Preservation Department – Item 1, LPC-23-08657

**346 Broadway (aka 108 Leonard Street, 46 Lafayette Street) – Former  
New York Life Insurance Building – Individual and Interior Landmark  
Borough of Manhattan**

# DESIGN REVISIONS

## IN RESPONSE TO COMMISSIONER COMMENTS

## FEATURE WALL

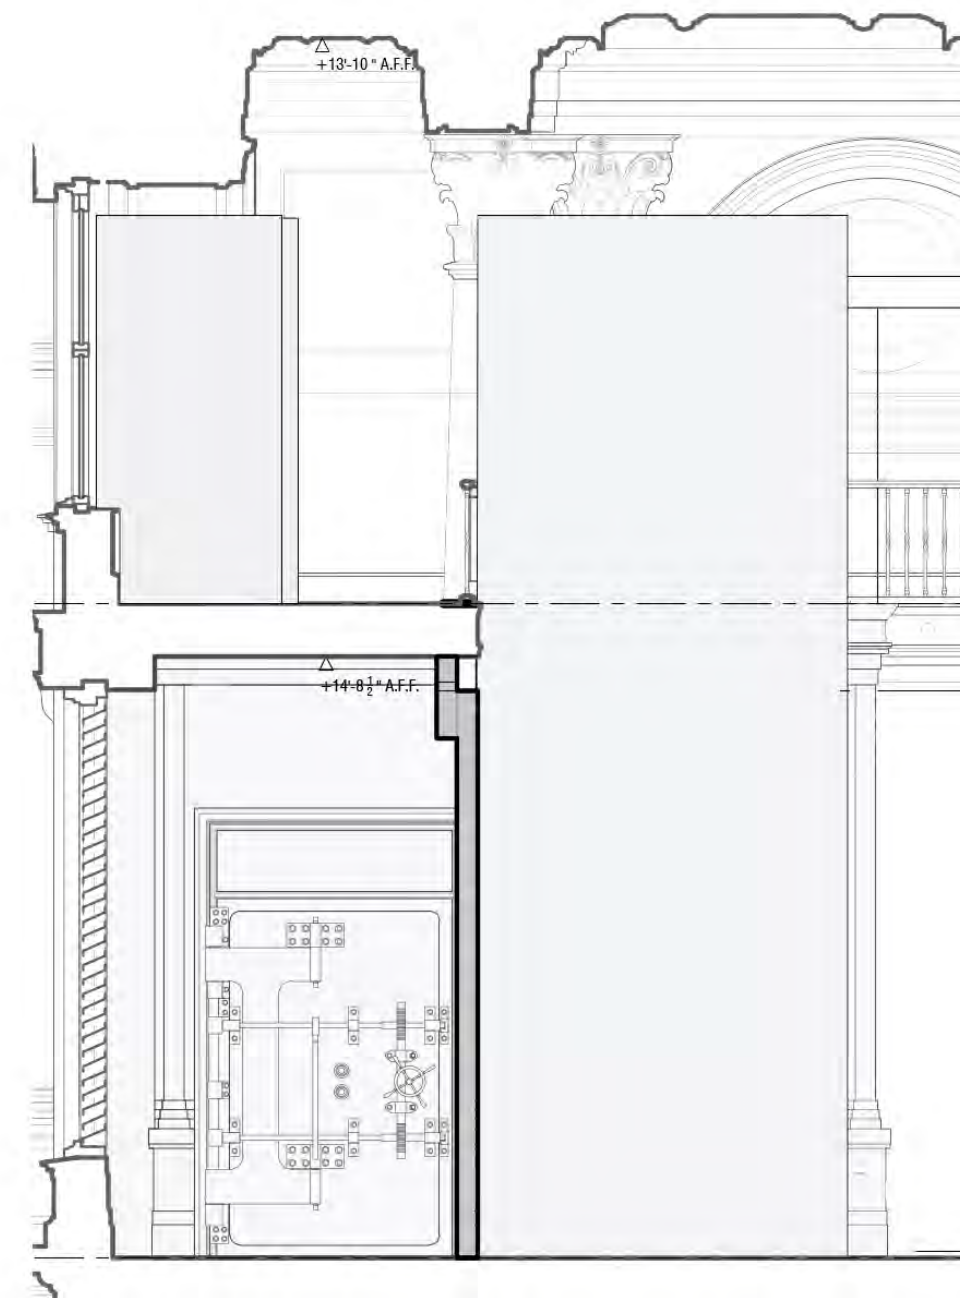
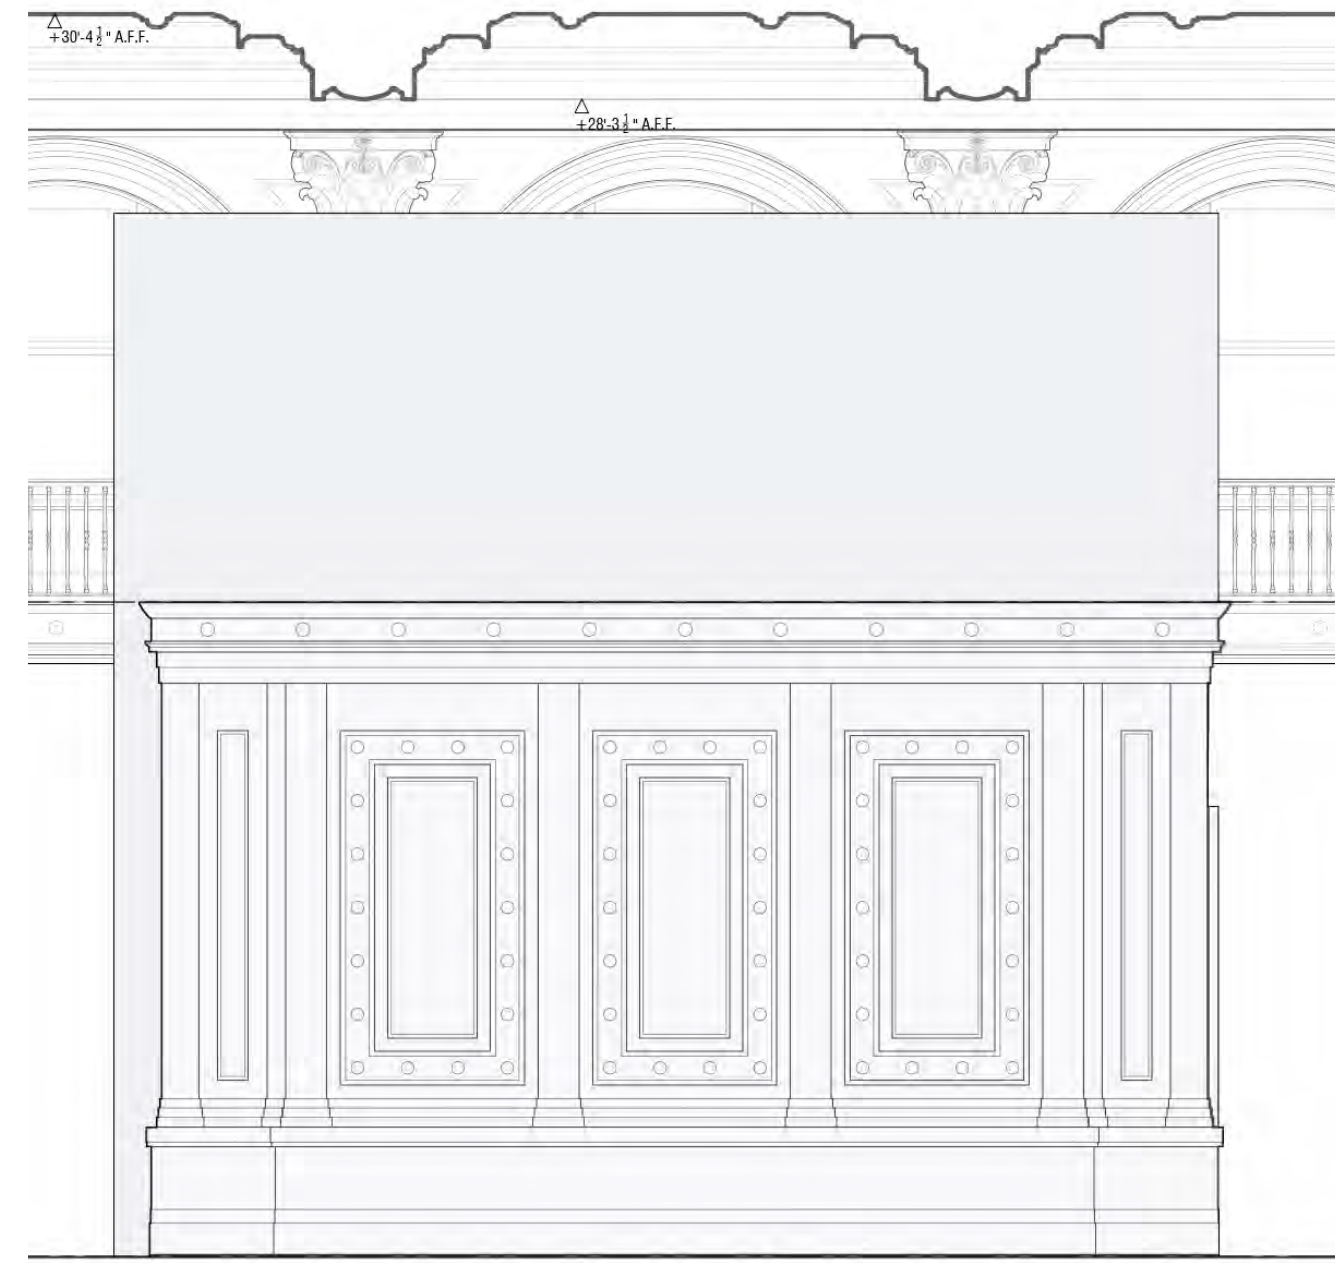
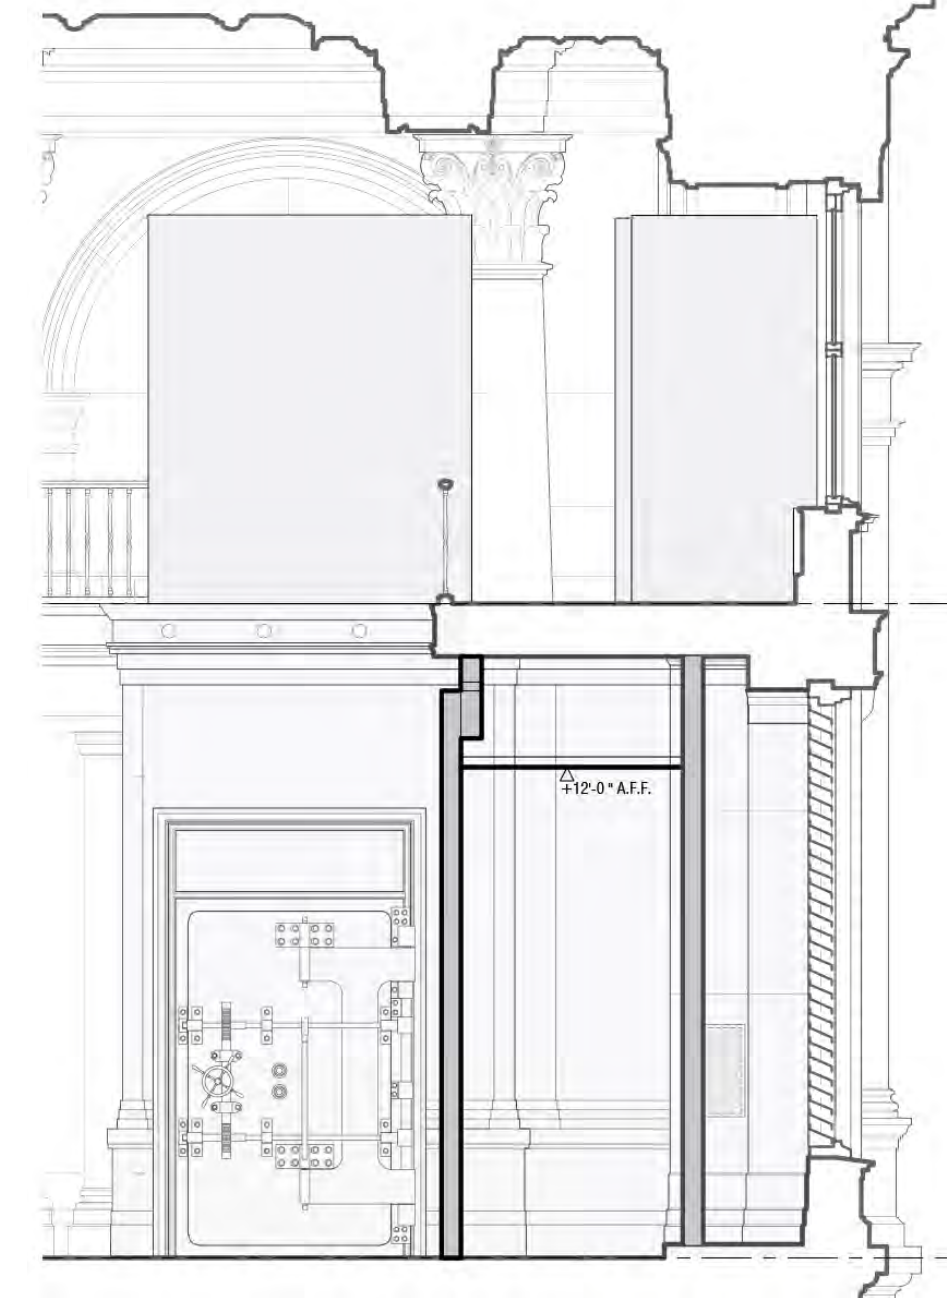
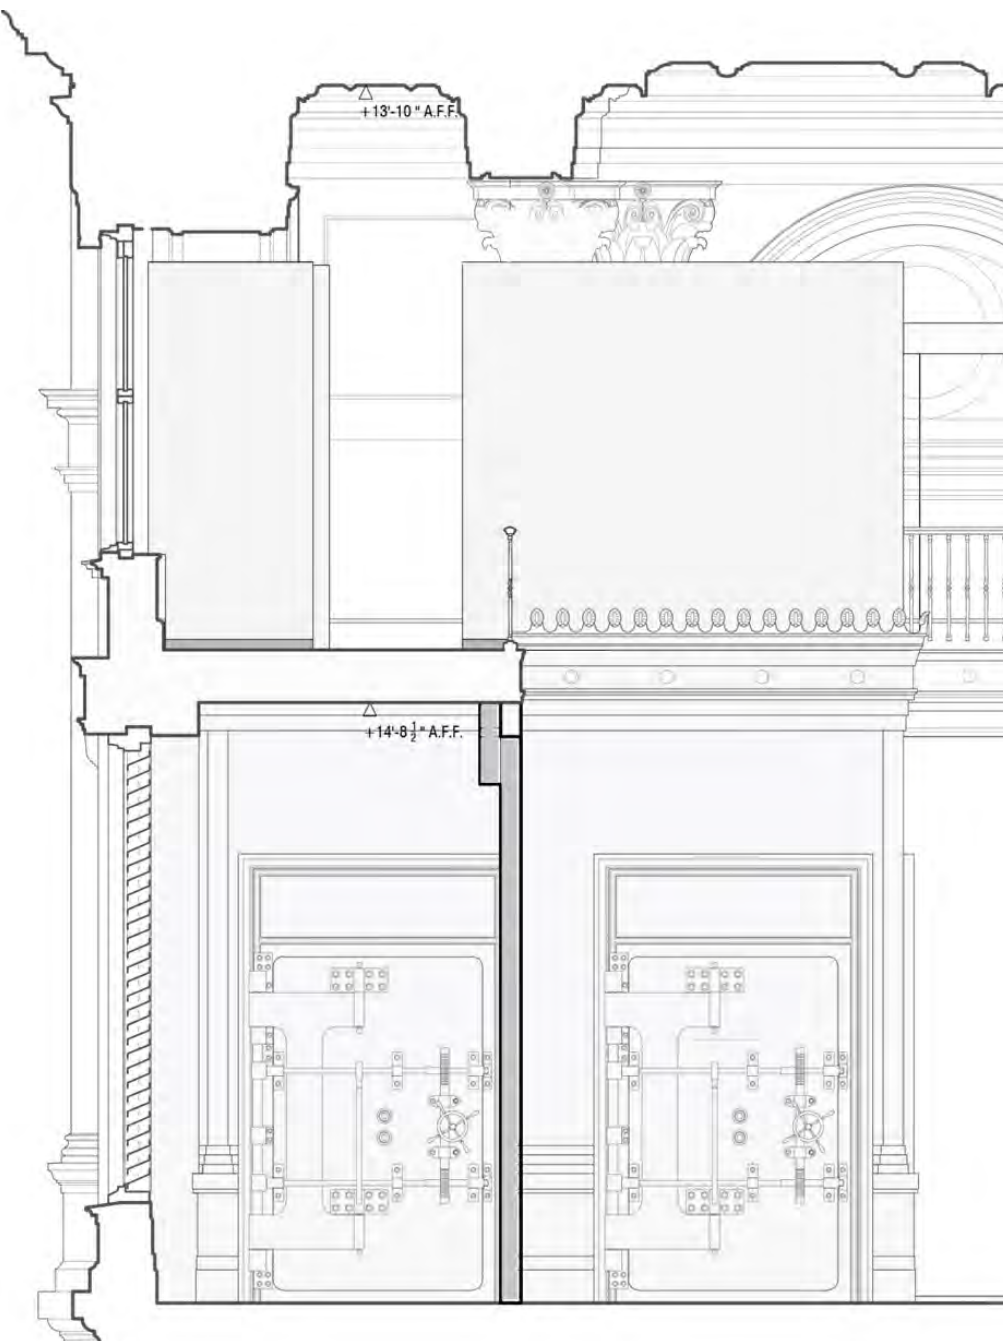
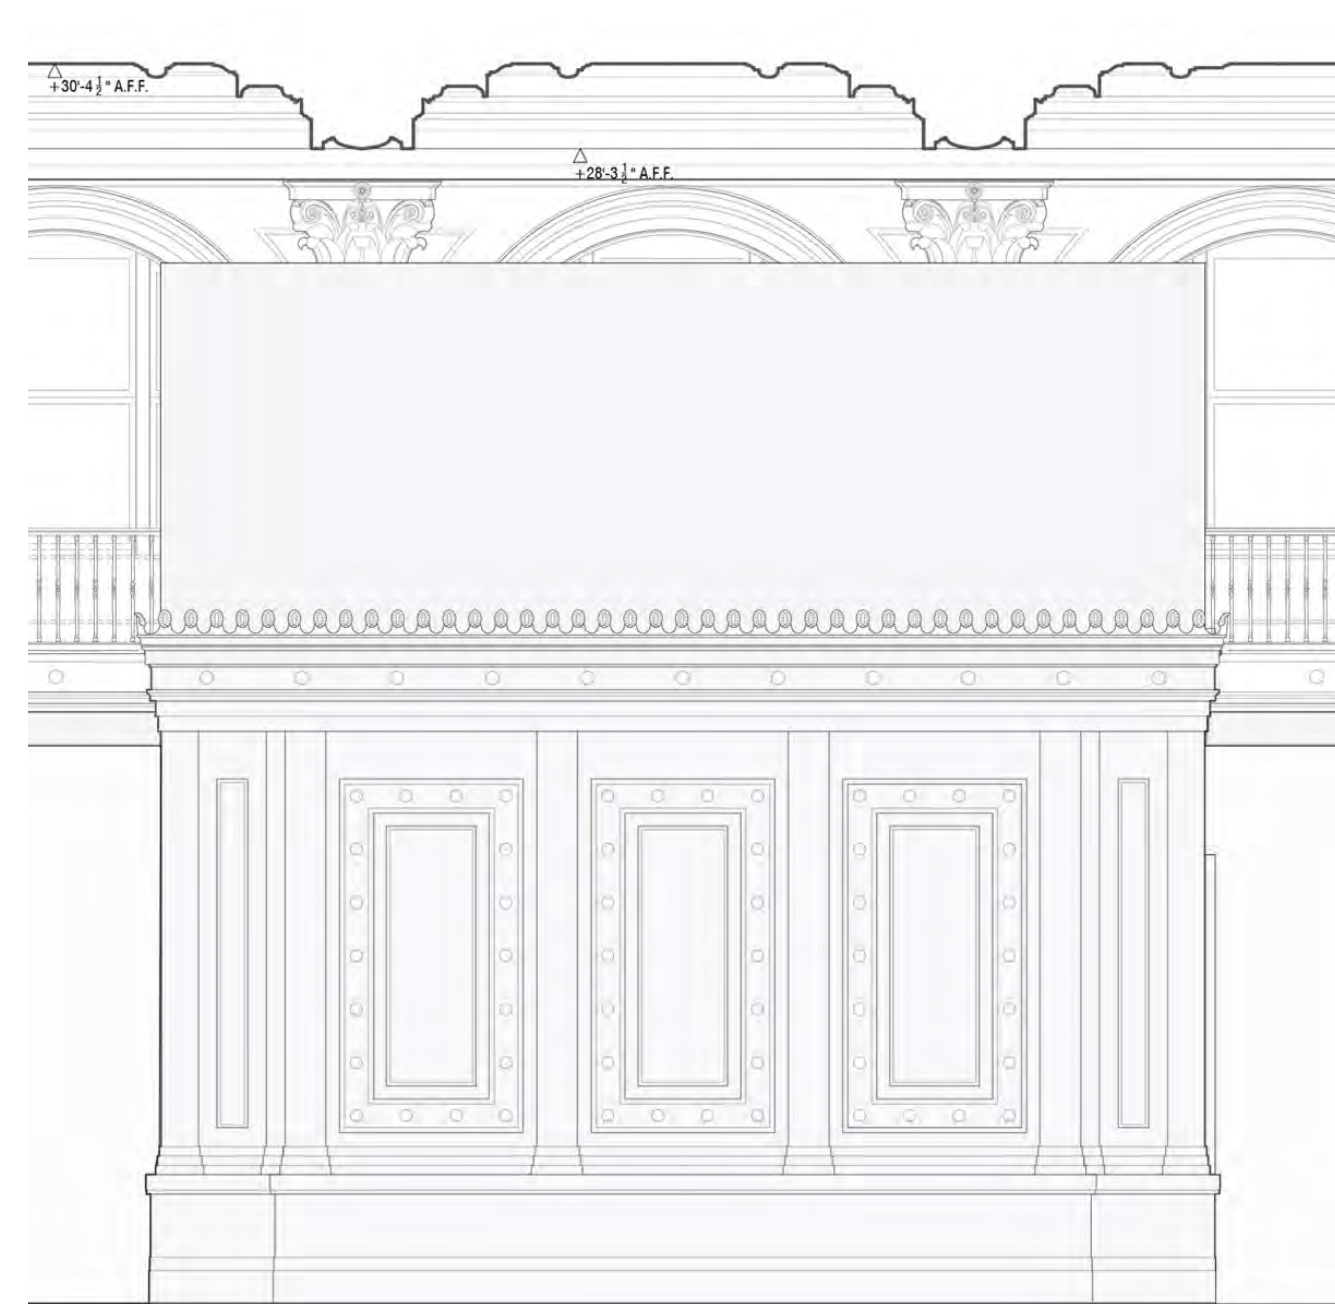
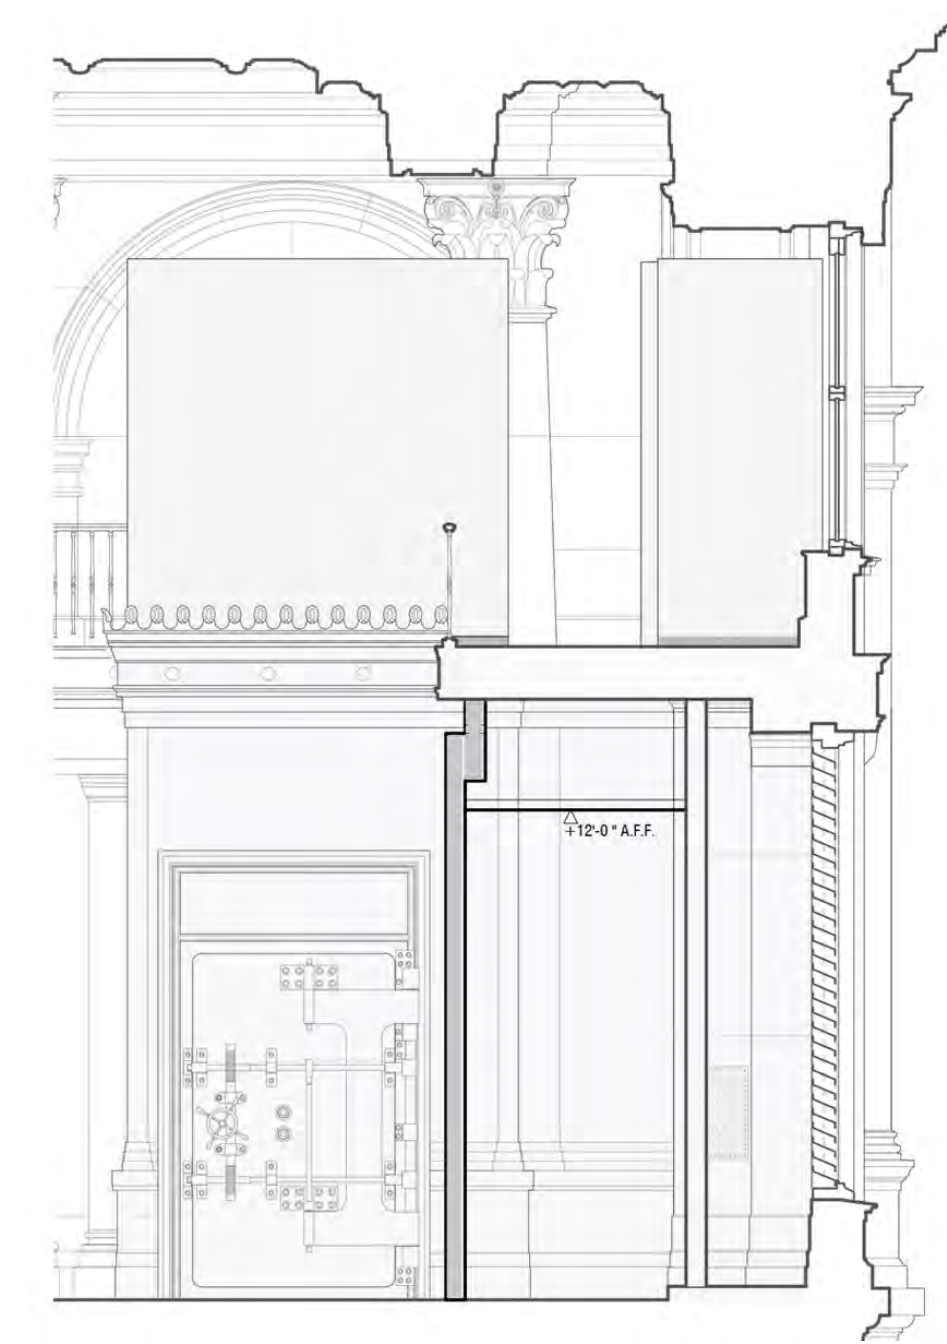
The feature wall has been removed to expose the east elevation and door of the vault. The vault's massing, details and finishes remain legible and the revised configuration preserves the vault as the dominant feature within the space.
